Mobile Intel[®] Pentium[®] 4 Processor-M

Specification Update

September 2004

Document Number: [250721-025](#)

Figure 13. System Bus Reset and Configuration Timings

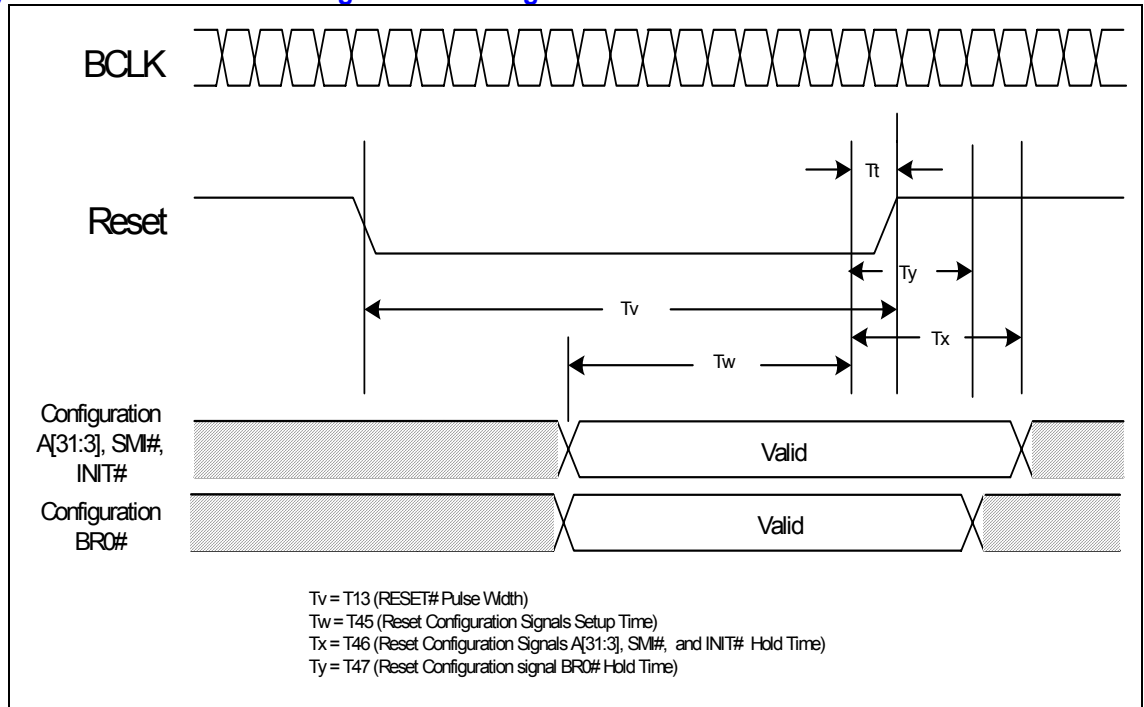
T2. BR0# Maximum Hold Time Specification Change

The BR0# maximum hold time has changed to 2 BCLKs. This change will be shown in the “System Bus AC Specifications (Reset Conditions)” table and “System Bus Reset and Configuration Timings” figure of the *Mobile Intel® Pentium® 4 Processor - M Datasheet*. This change will be incorporated in the next revision of the datasheet.

The following figure will be modified to reflect this change:

T# Parameter	Min	Max	Unit	Figure	Notes
T45: Reset Configuration Signals (A[31:3]#, BR0# INIT#, SMI#) Setup Time	4		BCLKs	13	1
T46: Reset Configuration Signals (A[31:3]#, INIT#, SMI#) Hold Time	2	20	BCLKs	13	2
T47: Reset Configuration Signal BR0# Hold Time	2	2	BCLKs	13	2
